CORNERSTONE PLANNED UNIT DEVELOPMENT

RESOLUTION NO. 14 SERIES 2023

A RESOLUTION APPROVING AN AMENDMENT TO THE CORNERSTONE FINAL PLANNED UNIT DEVELOPMENT REGARDING FENCE REGULATIONS

Cornerstone Fence Amendment Exhibit

CORNERSTONE P.U.D.

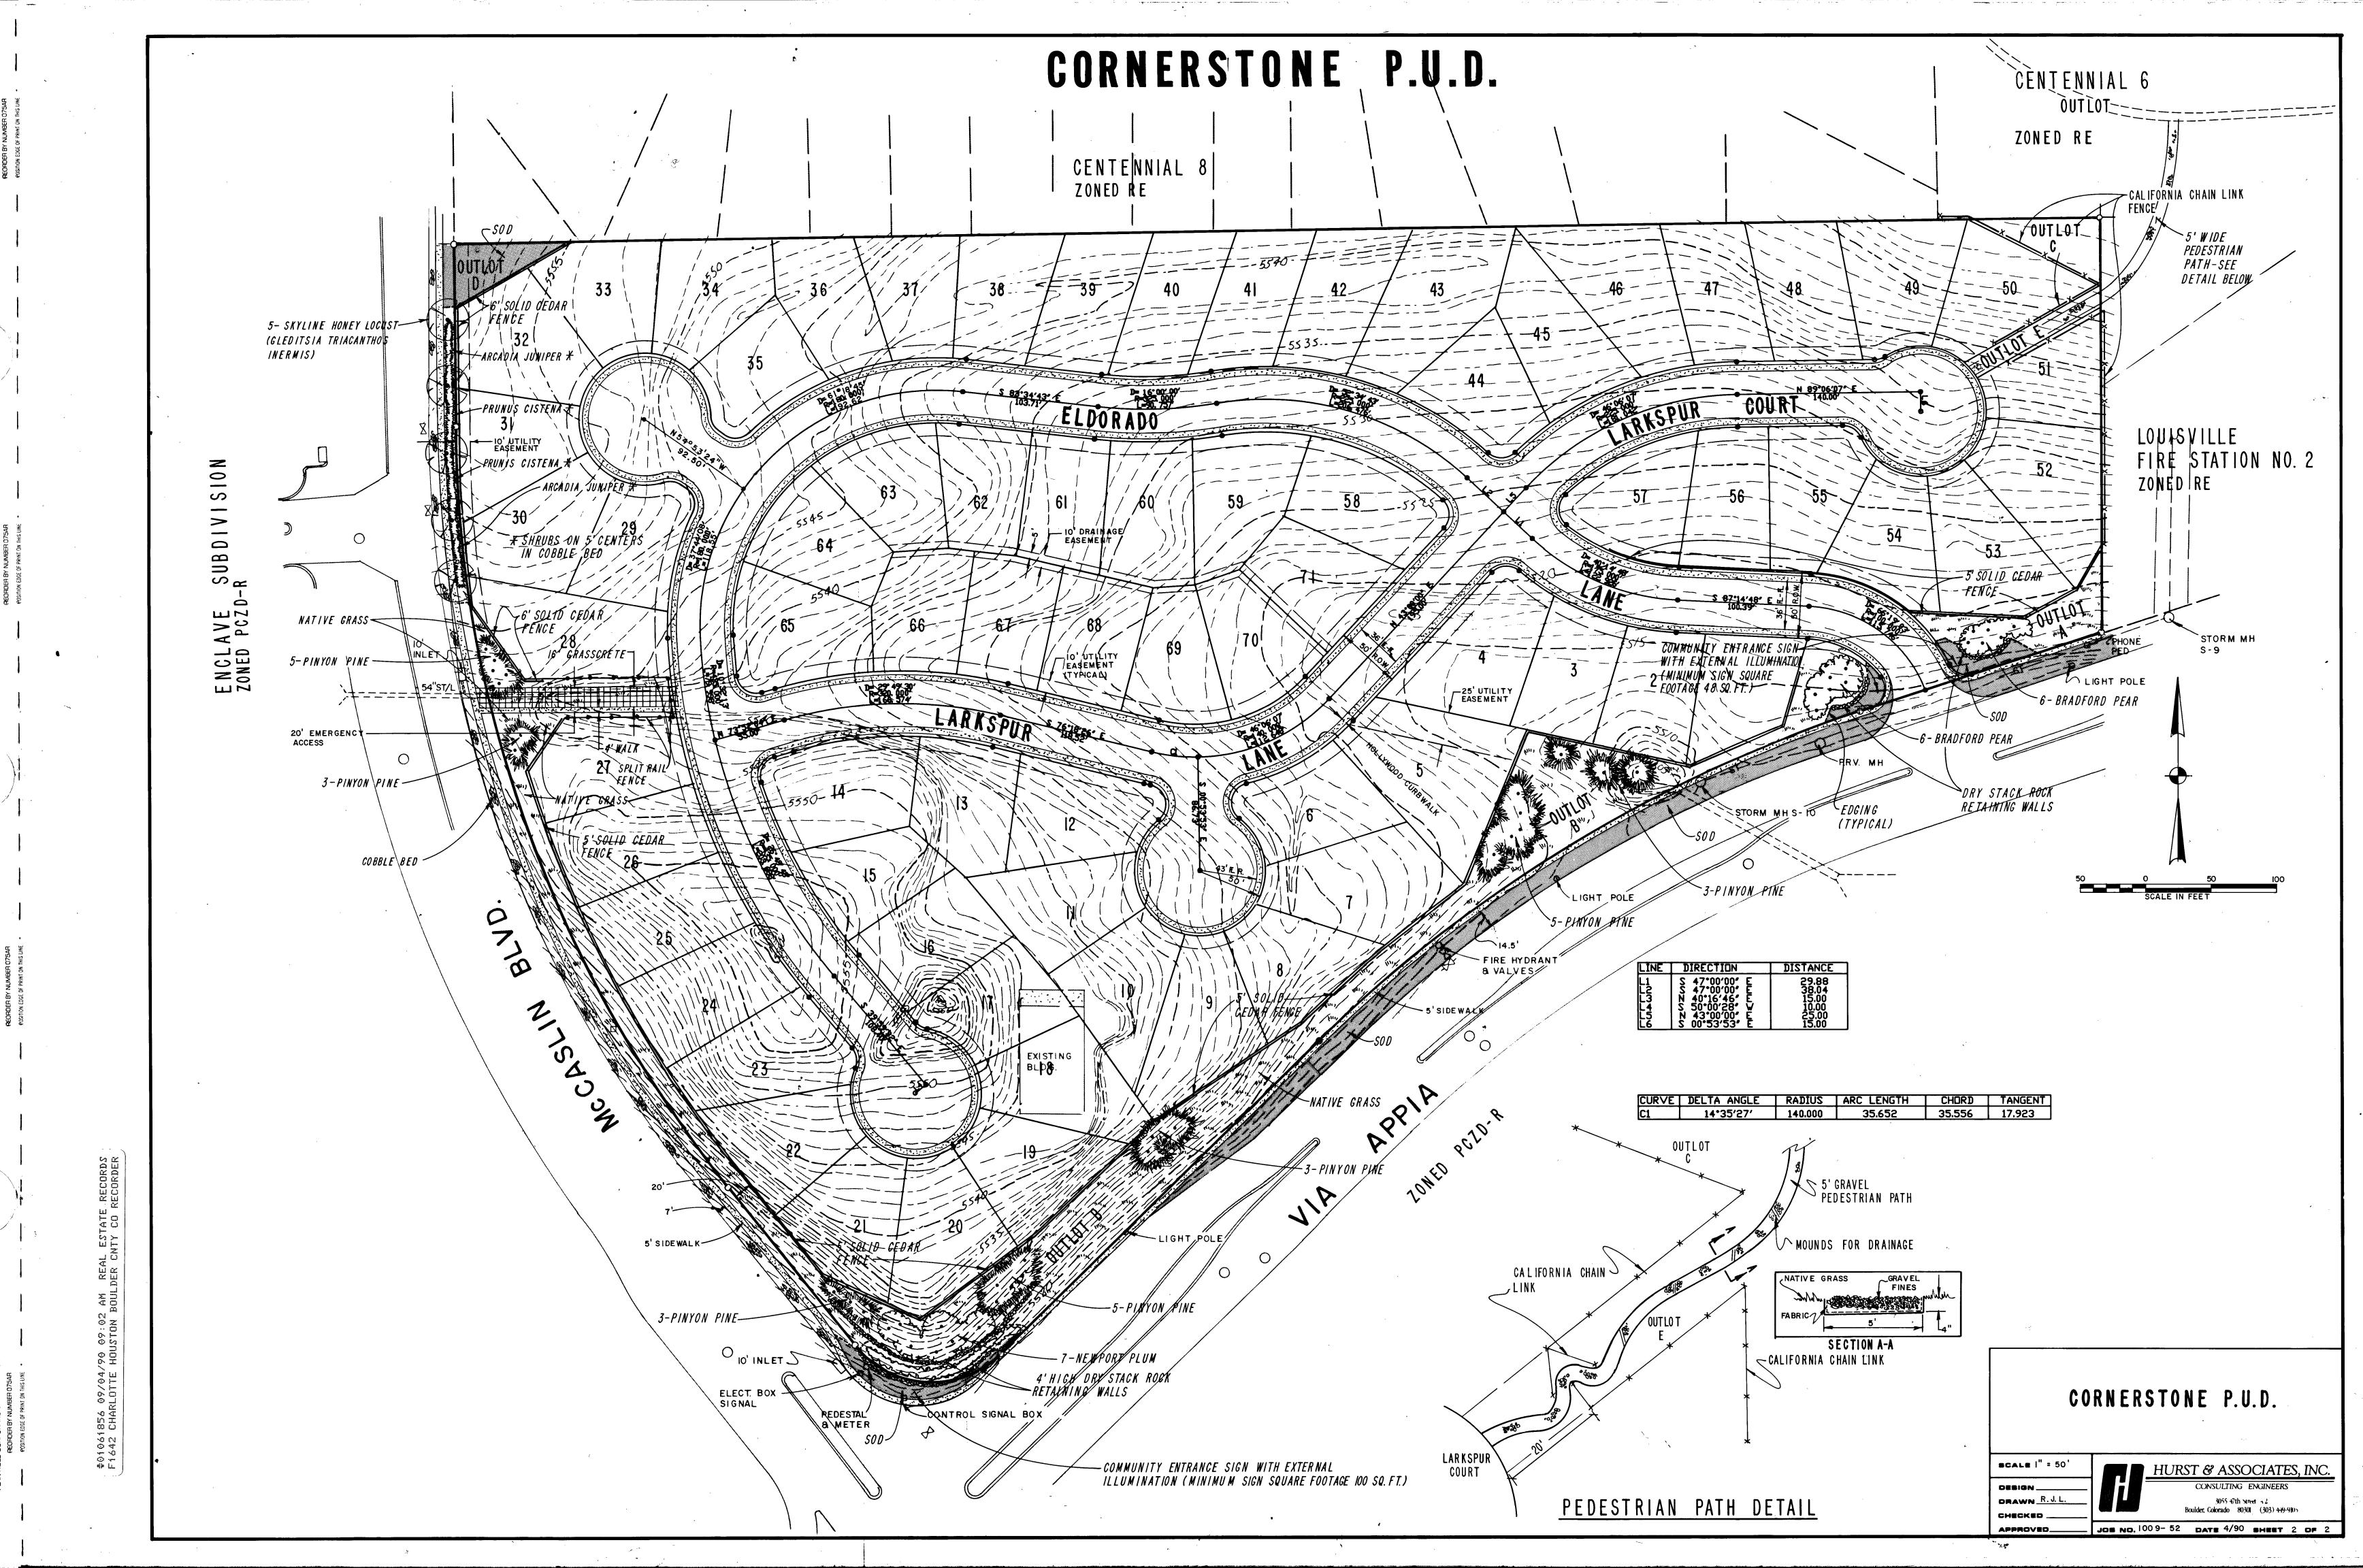
See Resolution 14, Series 2023 for revisions to fence regulations (attached to this pdf).

3/25/92. Fence support post spacing amended to permit 5' spacing. John Franklin DCD.

Notes:

- 1. This PUD Amendment replaces all fence regulations for the Cornerstone PUD
- 2. Solid fence setbacks
 - 18' front
 - 0' side or rear property lines
- 3. Fences not regulated by this amendment are subject to the Louisville Municipal Code Section 17.16.120.
